**MODIFICATION REQUEST:  
Sydney Metro City and Southwest –  
Chatswood to Sydenham**

**Modification to Martin Place Metro Station  
(SSI 7400 MOD 3)**

Environmental Assessment Report  
Section 115ZI(2) of the  
*Environmental Planning and Assessment Act 1979*

December 2017

**Figure 3 – Sydney Metro Martin Place Station – proposed modification layout**  
(Source: Martin Place Station Modification Submissions Report, Transport for NSW, 2017)

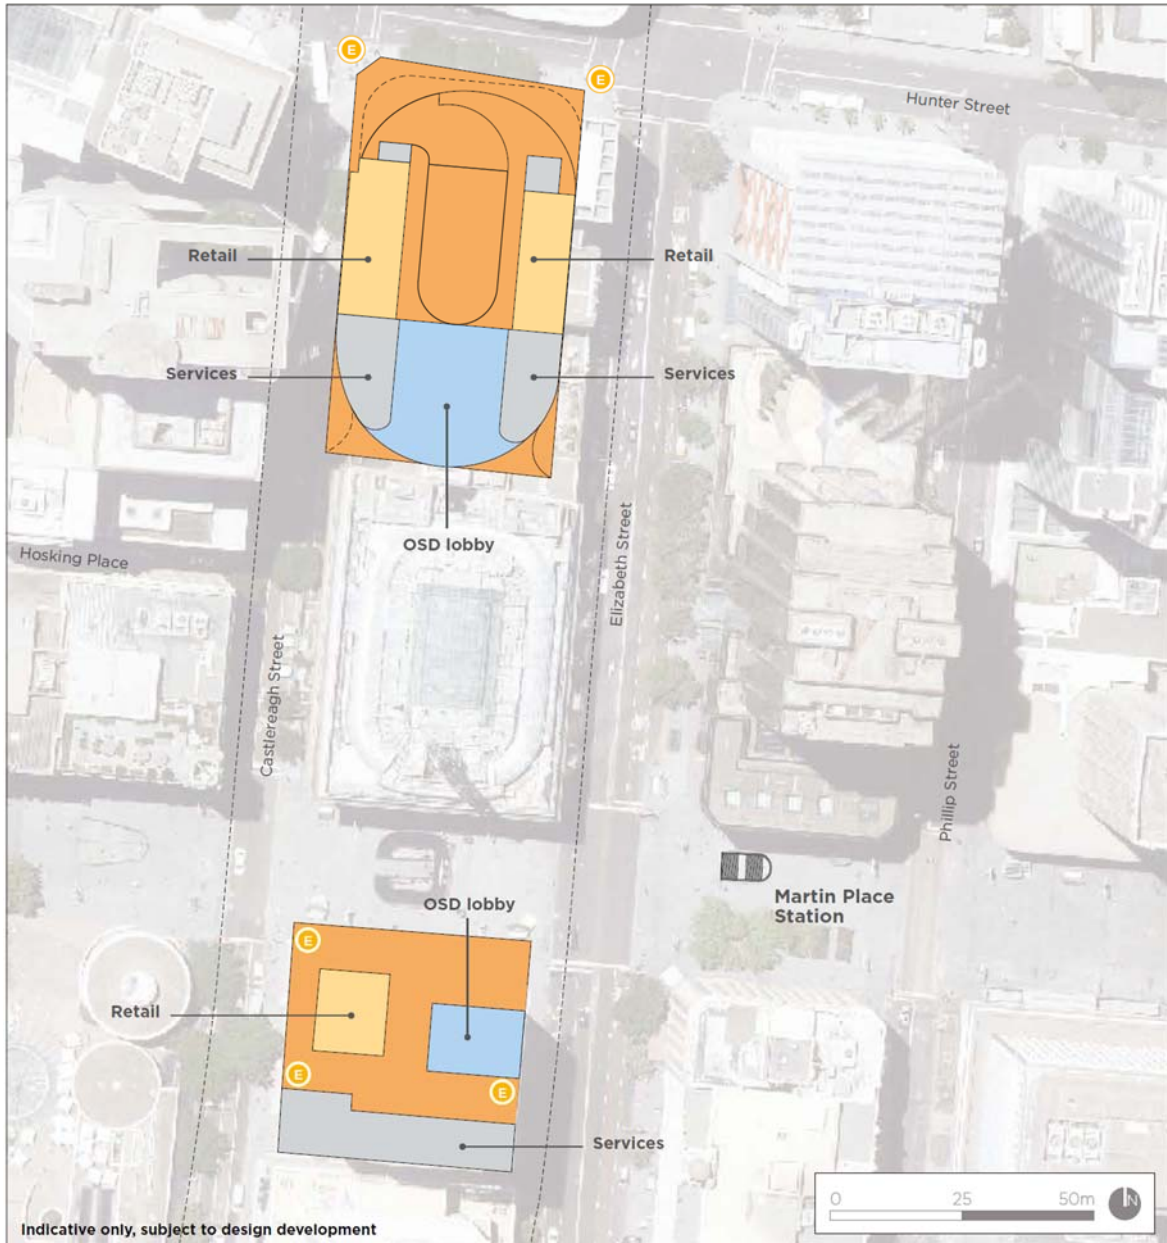
*Note: City of Sydney Council identified that the indicative station layout included with the modification did not show the location of the lobbies for the proposed over-station developments on either the northern or southern sites. This has been corrected and is shown in **Figure 3** below.*
